WATER QUALITY MEMORANDUM

Utah Coal Regulatory Program

November 20, 2008

RE: 2008 Third Quarter Water Monitoring, Nevada Electric Investment Corporation, Wellington Preparation Plant, C/007/0012, Task ID #2676

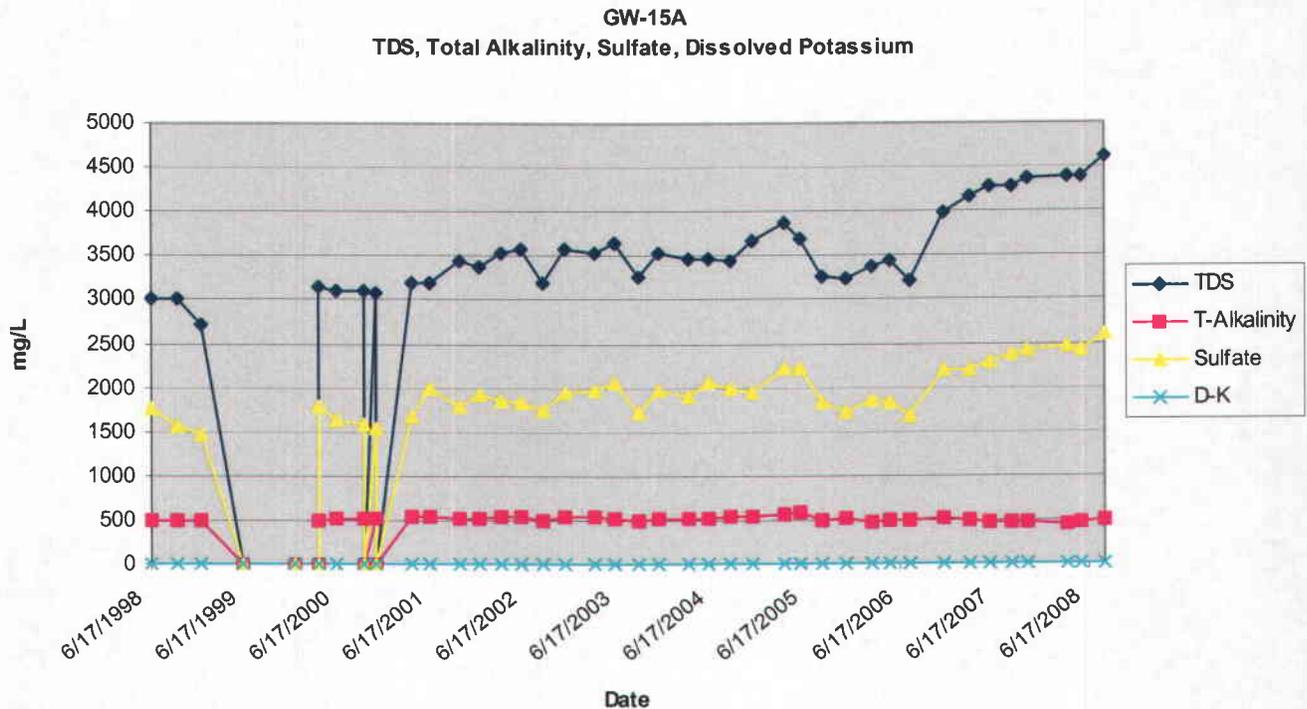
Several parameters have been outside two standard deviations from the mean at GW-15A and GW-15B. Upward trends for TDS and sulfate are shown in GW-15A (see chart below); data for GW-15B are similar.

Additionally, based on elevated trends in TDS and other parameters seen in both GW-15A and GW-15B, which are located north of Siaperas Ditch, the Permittee should examine these data more closely to draw conclusions as to the reason for these upward trends in TDS, sulfates and other parameters are present.
